McClellan Apartments

Recommendation Meeting
Updated March 21, 2013

DPD Project# 3012392

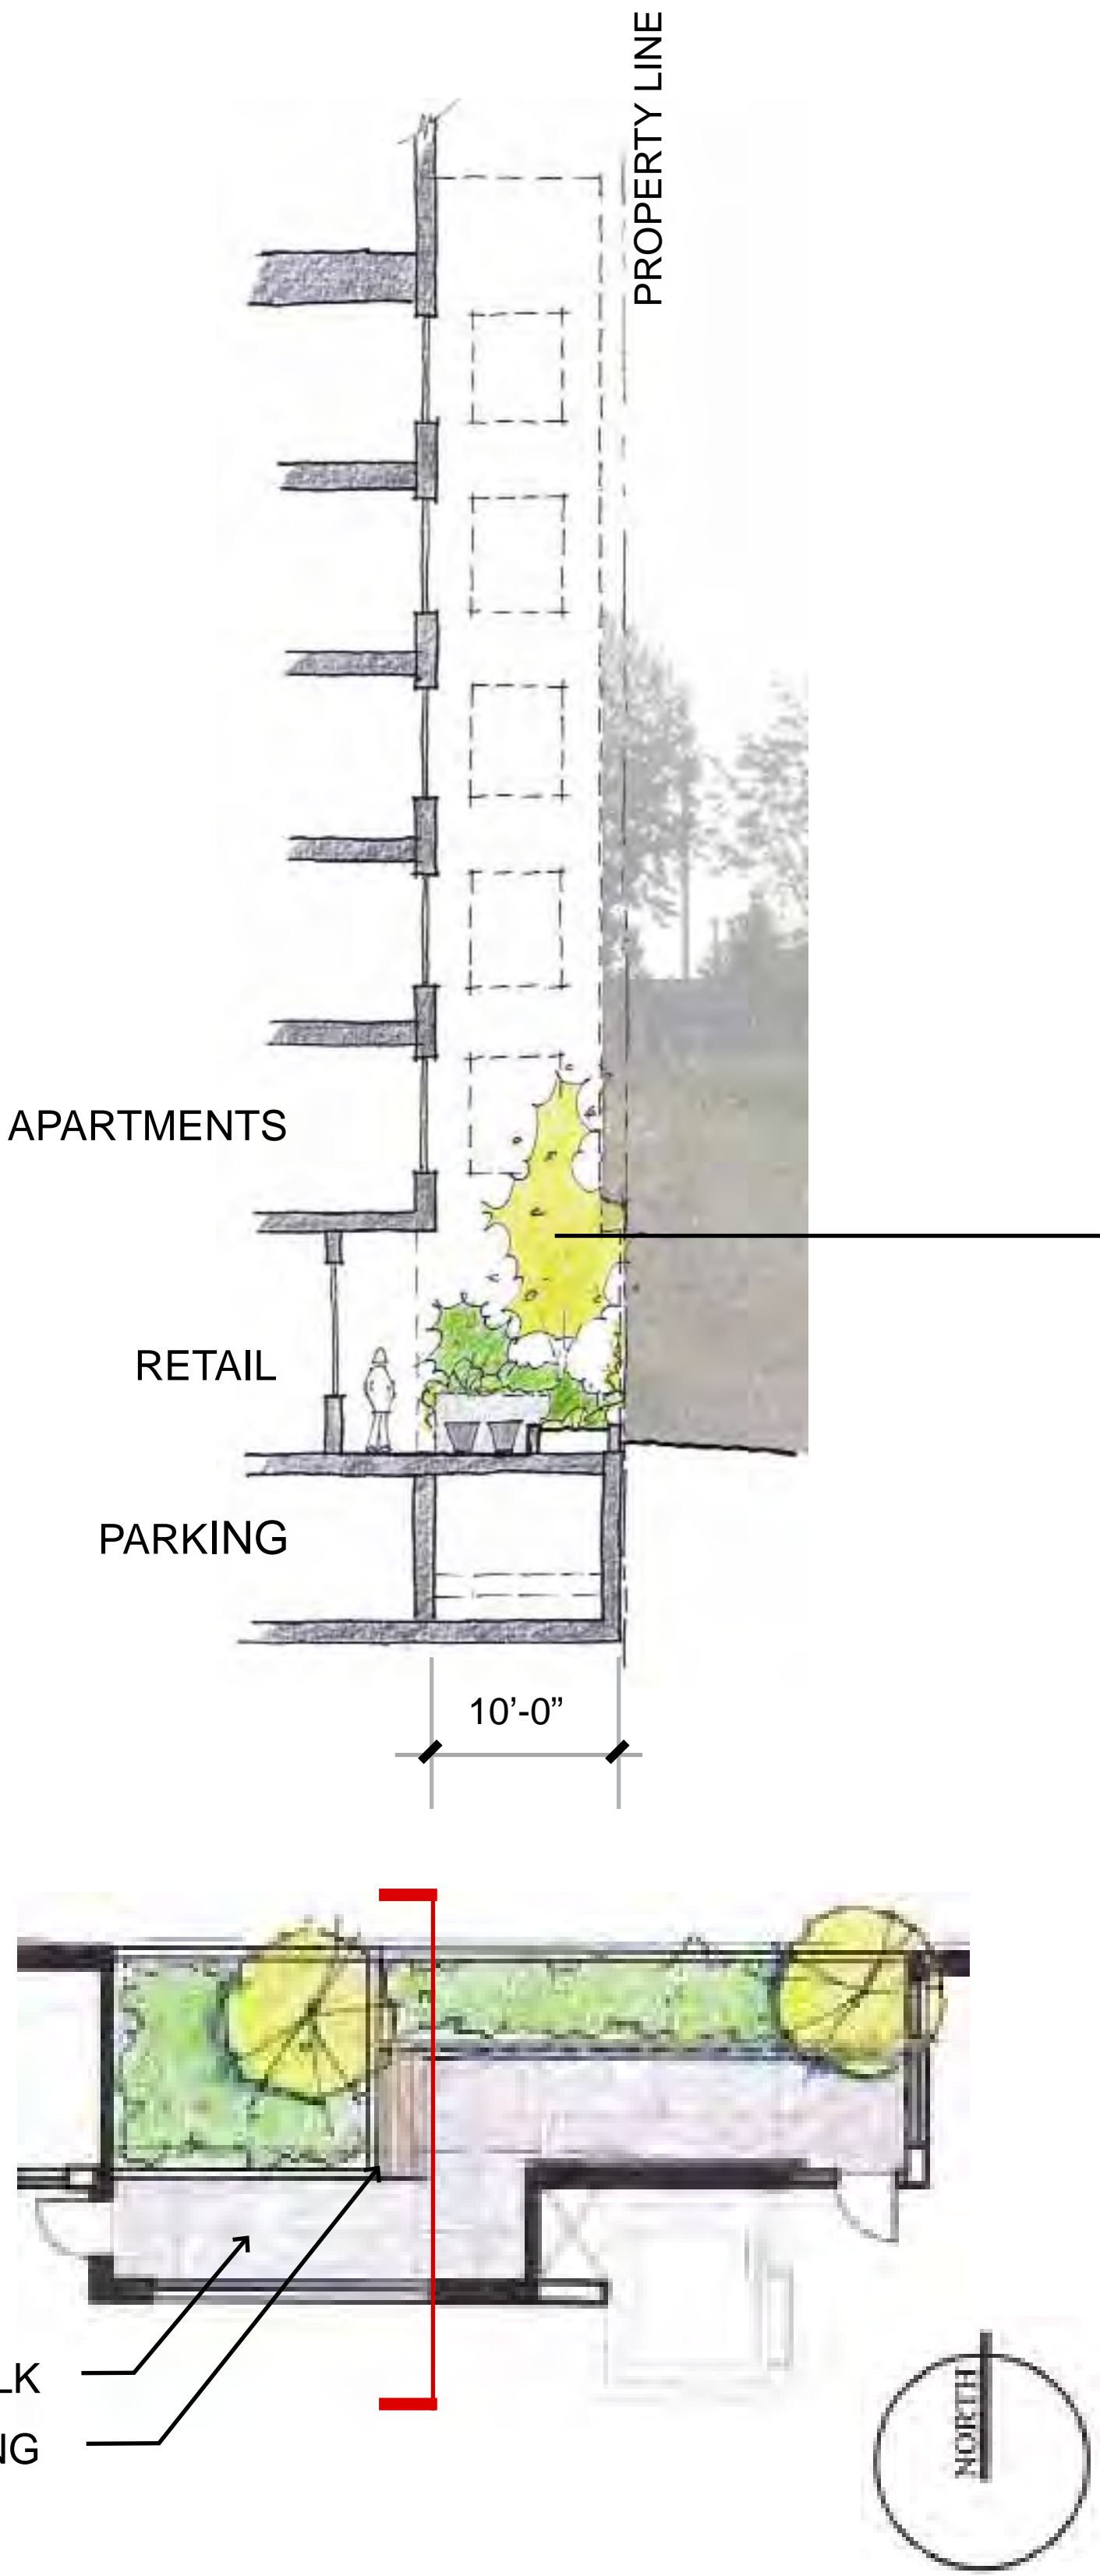
DRB Guidance

- Landscape should be used to enhance building
- Courtyard at north side and stoops along 17th particular areas of landscape opportunity

Response

- Landscape areas at McClellan soften building edges, define public spaces and building entrances, provide shade, and slow stormwater flows in a bioswale.
- Landscape at 17th is primarily native plants, with trees and understory emphasizing the rhythm of the facade, help scale down the building for transition to single family zone across the street
- At alley and north facade, planters and maximize limited space to introduce small trees, and lush green to courtyard and building edges.

Departure 1: SMC 23.47A.005 Street Level Uses

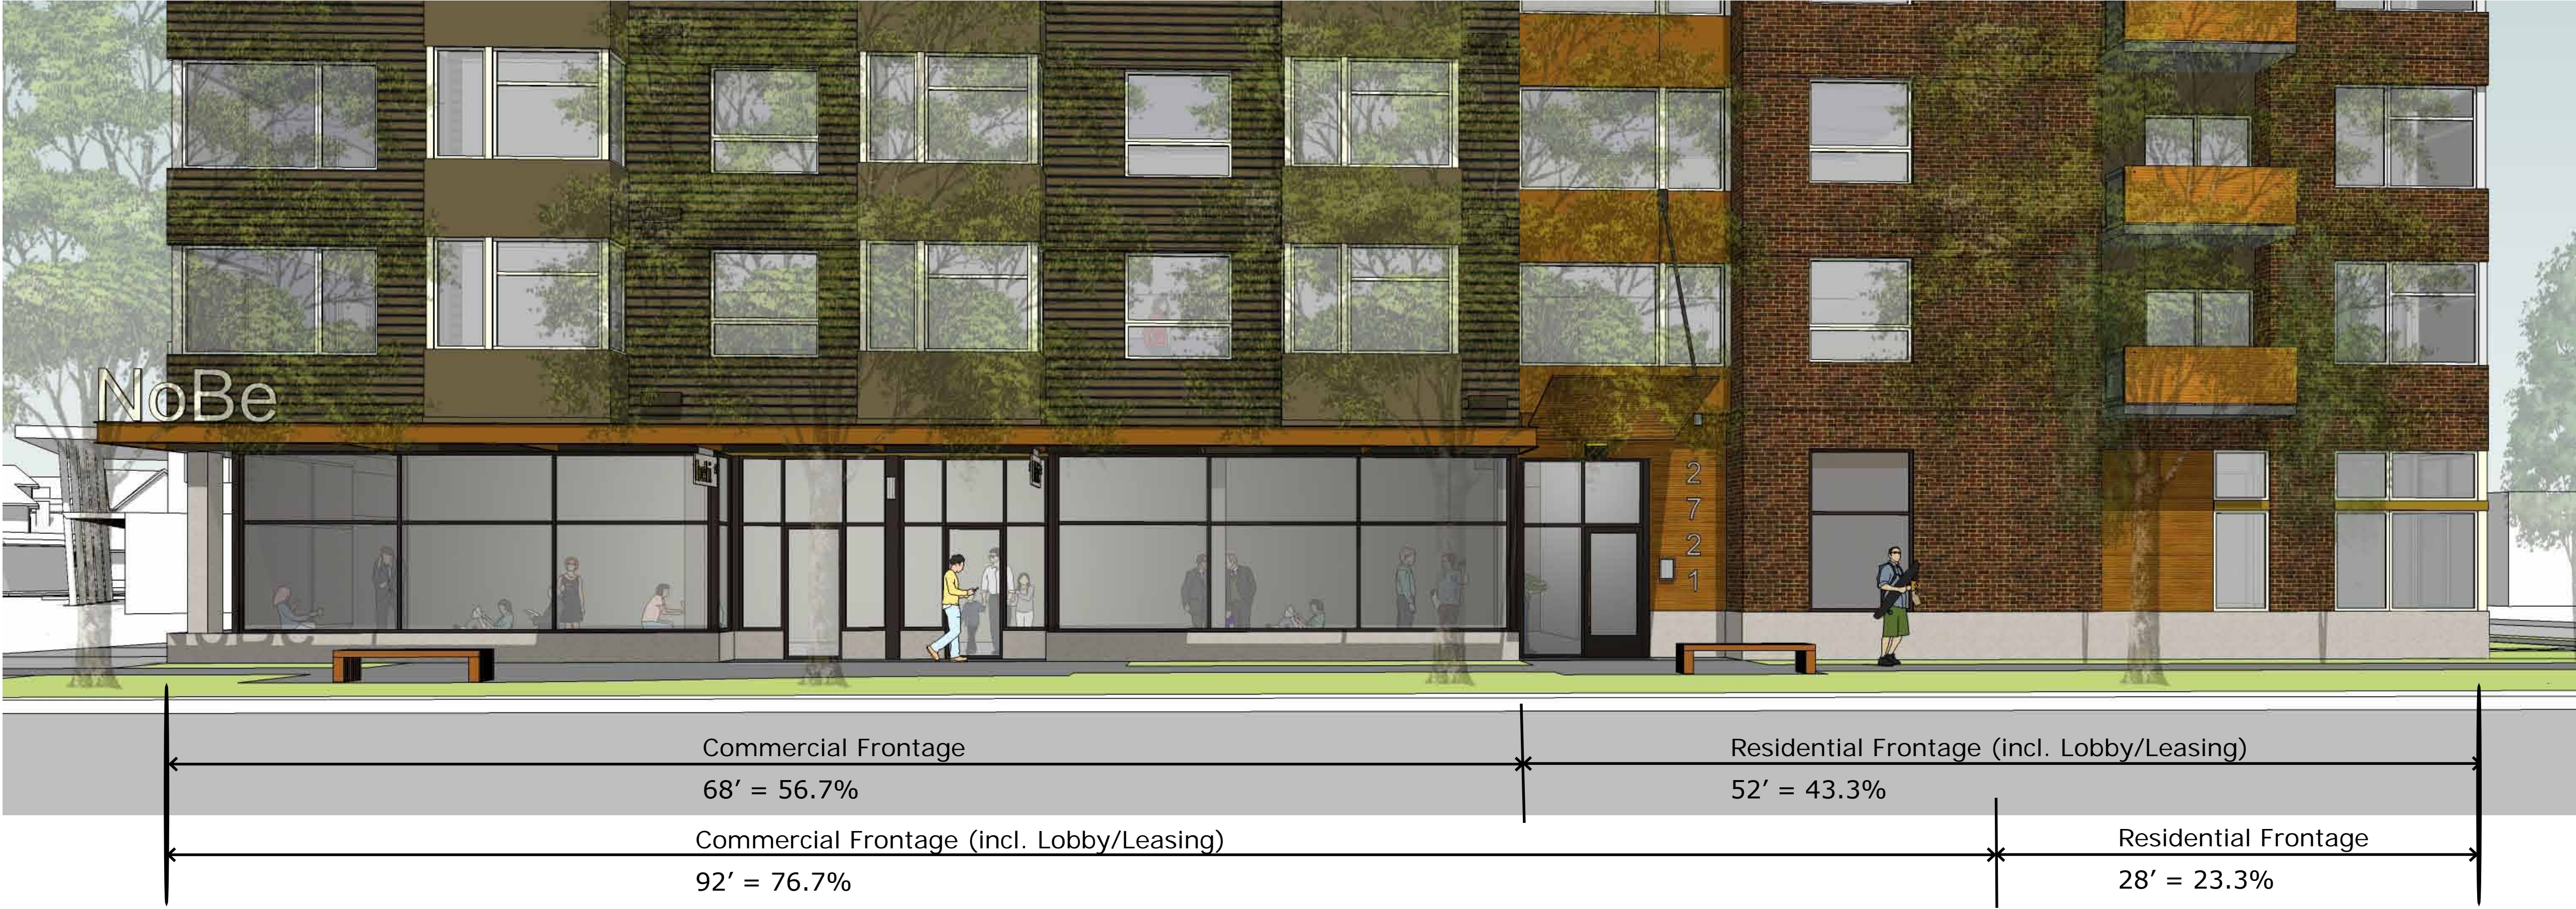
Residential uses along McClellan (a principal pedestrian street) at street level limited to 20%, or 24’ out of 120’ total street frontage

Requested Departure

Provide 43.3% or 52’ of residential street frontage.

Justification

- Residential use at 17th Avenue is compatible with existing residential use and scale at 17th
- Residential units will need a feasible depth along McClellan, providing a transition along McClellan between the existing commercial character to the West and the existing residential character of the East
- Community requested dwelling units along 17th to respond to single-family residential character
- Uses along McClellan transition from the alley along the west side with commercial/retail (Public), to apartment entry lobby (Semi-Public), to leasing office (Semi-Private), finally to dwelling unit (Private)
- Frontage of all spaces with commercial character (incl. lobby and leasing office) = 92’ or 76.67%, leaving 23.33% for spaces with residential character
